Docket Number:	00-AFC-14C
Project Title:	El Segundo Power Redevelopment Project Compliance
TN #:	201717
Document Title:	Data Responces 2/12/14 from NRG
Description:	E-mail
Filer:	Christine Stora
Organization:	California Energy Commission
Submitter Role:	Commission Staff
Submission Date:	2/12/2014 2:44:45 PM
Docketed Date:	2/12/2014

From: Piantka, George [George.Piantka@nrgenergy.com]
Sent: Wednesday, February 12, 2014 1:34 PM
To: Stora, Christine@Energy
Cc: Miller, Elena@Energy; Marxen, Chris@Energy
Subject: RE: ESEC Outstanding Information Update Needed
Attachments: MBC ESEC Bio Closeout Report Feb 2014.pdf; MBC ESEC Bio Closeout Report 2011 2012.pdf; ESEC_00-AFC-14C_HAZ-3-RMP_01-18-13 .pdf; Revised Table 2-14 HazMat Use and Storage ESEC PTA 00-AFC-14C 02122014.docx

El Segundo Power LLC	
AQUEOUS AMMONIA UNDERGROUND TANK (Top View) 301 Vista Del Mar Boulevard El Segundo, California 90245	
Proj. No.: URS 29880137	Date: 9/2011
Project: RMP Update	Figure: 3

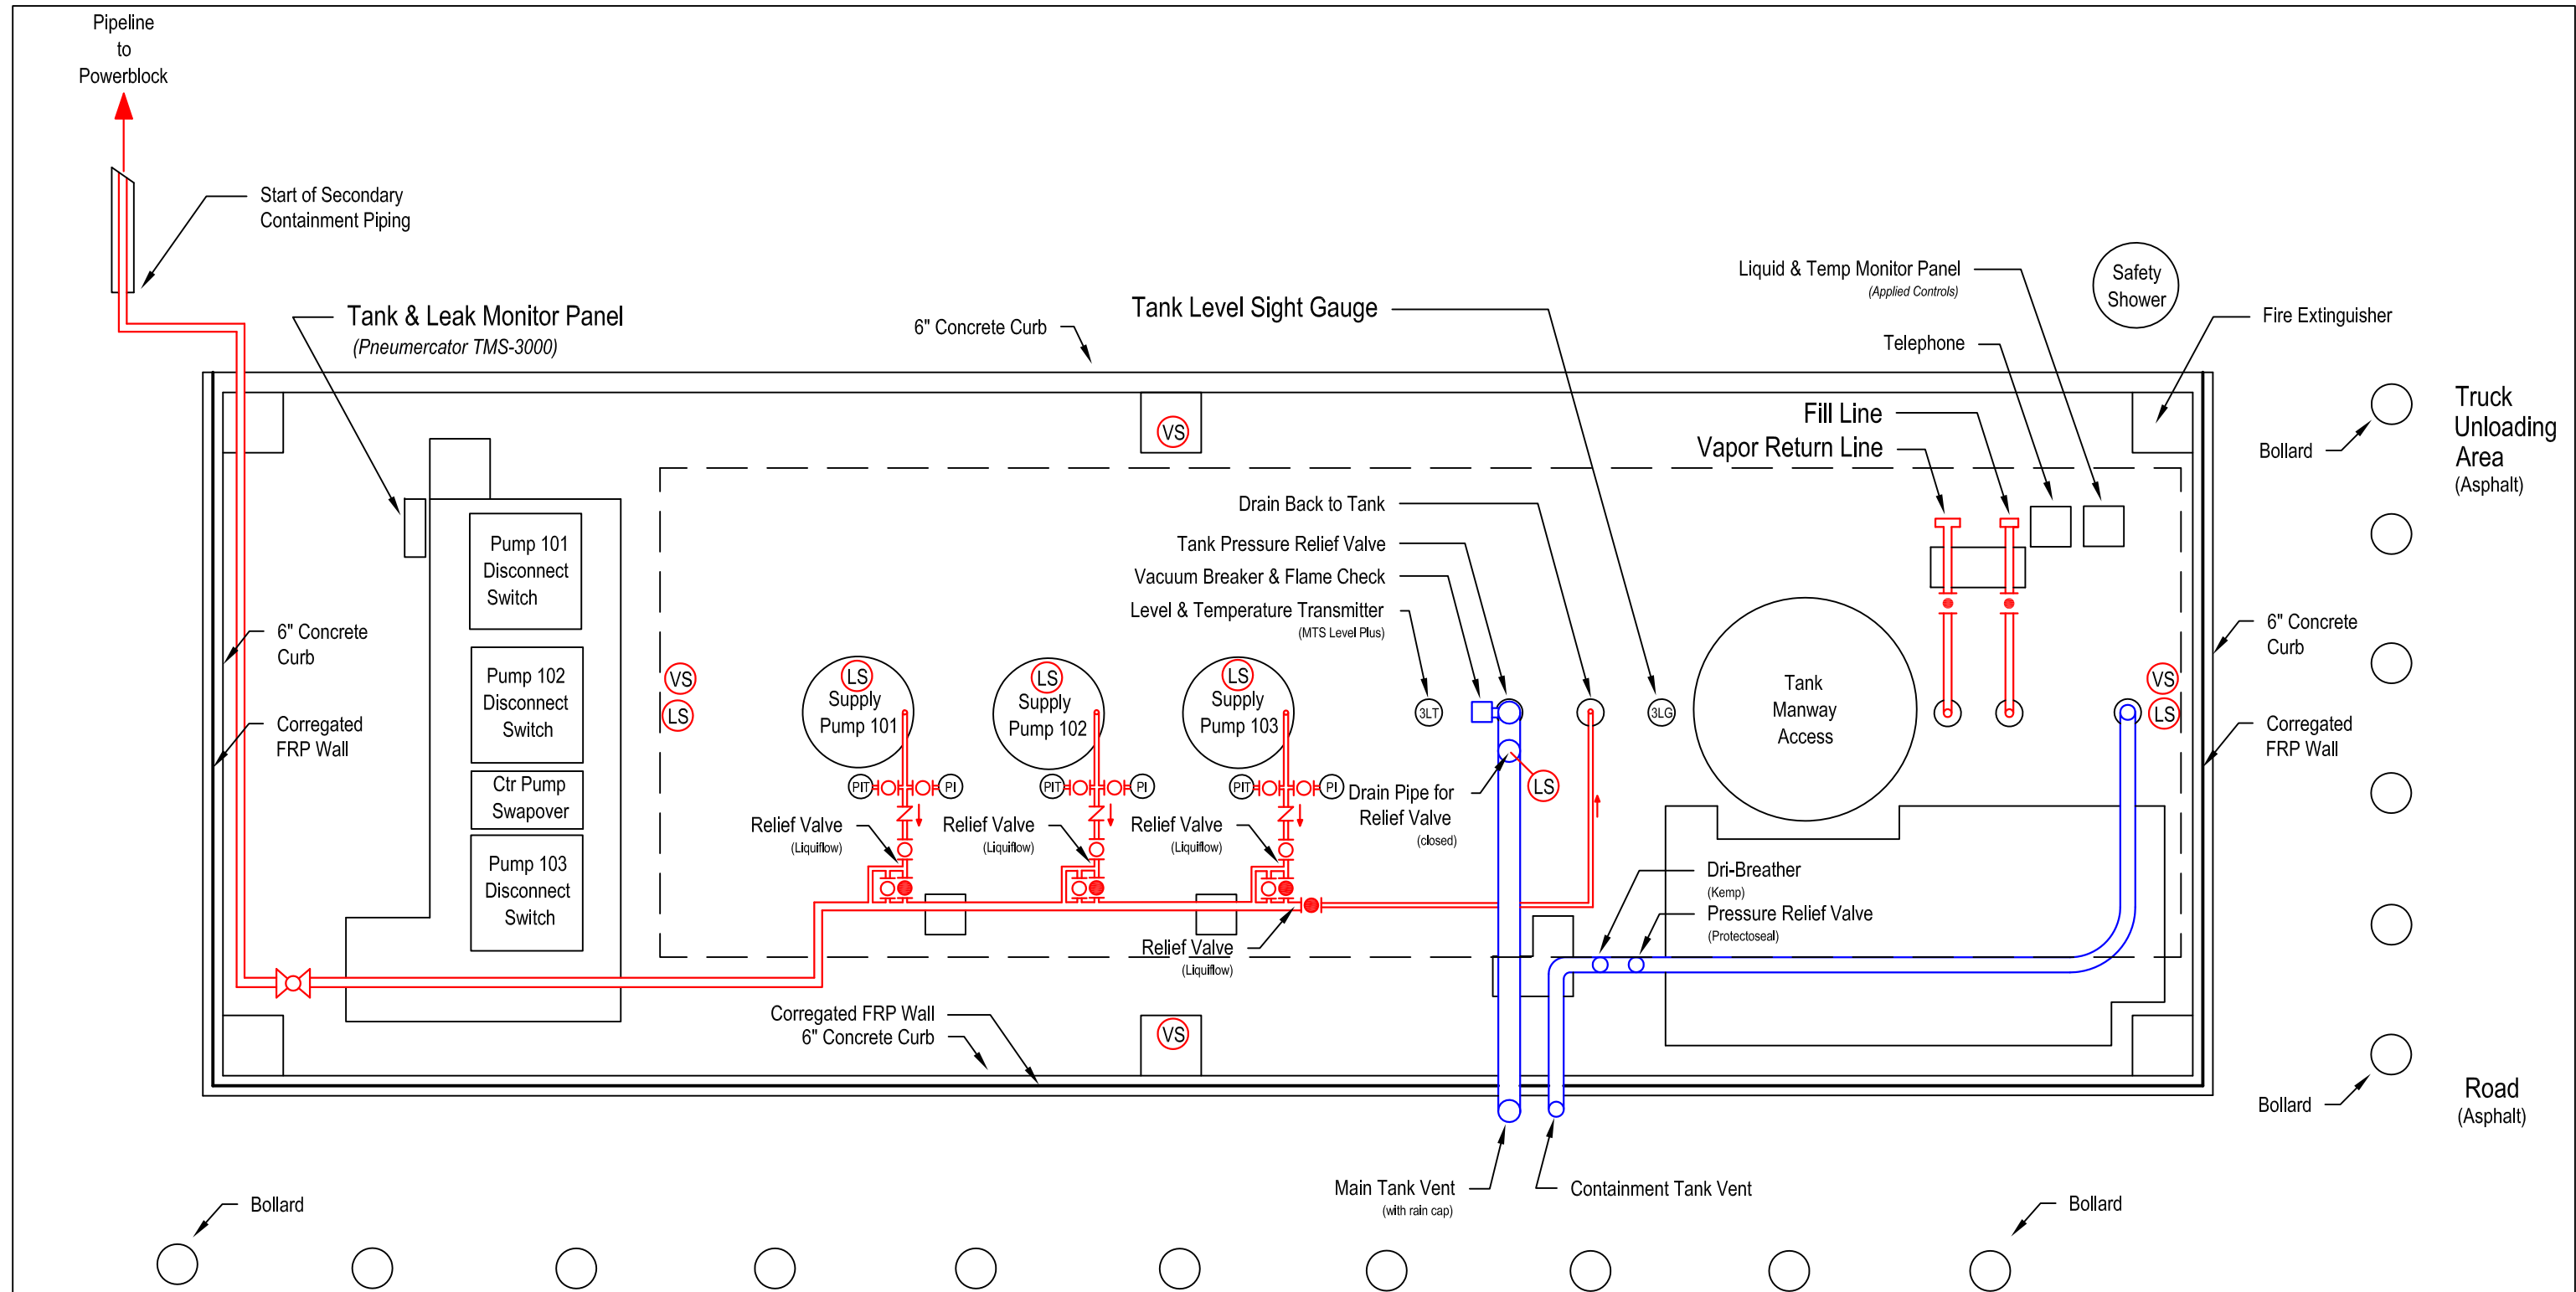
5. Aq. ammonia will be used and stored at two locations on the site: 1000 gal steel drum or tote south of the Unit 4 Boiler and a 20,000 gal underground tank at the top of the hill. Correct? Please identify where the "top of the hill" is located and show on a map of the site.

6. Please provide a schematic diagram of the two locations of aq. ammonia storage showing the drums/totes and underground tank (what is the depth of the tank bgs?), and secondary containment and tanker transfer pads. Is the underground tank double-walled which would serve as the secondary containment?

Response - Ammonia for Units 4 boiler's SCR and ESEC Units 5 and 7's SCRs is supplied from the existing double-walled 20,000 gallon UST, which contains 29% ammonia. The 20,000 gallon UST is located near the entrance to the plant (see the attached current Risk Management Plan). This tank was documented in the original AFC (and the Decision) as the supply for ammonia for the El Segundo Power Redevelopment Project's 2x1 combined cycle plant and for steam boilers Units 3 and 4. With the completion of construction of ESEC Units 5-8, the existing 20k gallon UST continues as the ammonia supply for Units 5 and 7 SCRs and for Unit 4 SCR. Two ammonia totes of 350 gallon capacity each (stainless steel within secondary containment) storing 19% ammonia were installed to provide pH control to Units 6 and 8 boiler feed. The final design of these totes is 350 gallons each and will be filled to 320 gallons each; this is a change from what is referenced in the current RMP. The 1000 gallon capacity tote or drum referenced in your request was the initial anticipated capacity for 19% ammonia storage, but following detailed design, stainless steel totes of 350 gallon each was manufactured

Response – Attached is the 2013 RMP with figures that depict the location of the 20,000 gallon double walled (for secondary containment) UST that stores 29% aqueous ammonia to supply the facility's SCR systems; the UST is near the plant entrance off of Vista Del Mar Blvd and the offloading pad is located adjacent to the UST location. A figure depicting the locations and sizes of the two aqueous ammonia totes and their respective secondary containment is being developed. The current RMP does not reflect the 350-gallon stainless steel totes. We are in the process of updating the RMP.

1. Top view of aqueous ammonia underground storage tank: 20,000 gallon, carbon steel tank contained in a FRP-clad containment tank below a concrete secondary containment pad and corrugated FRP siding (except north side) and roof.
2. For specific tank details, see Drawing 5235705-1, SCR Aqueous Ammonia Storage Facility Piping Plan & Sections. Electrical conduit and controls not shown.
3. Pneumercator Tank Monitor Panel monitors leak sensors with local alarm + wired to the Applied Controls Monitor Panel which transmits alarm signal to Control Room. Liquid leak alarms interconnected to shut-down supply pumps.
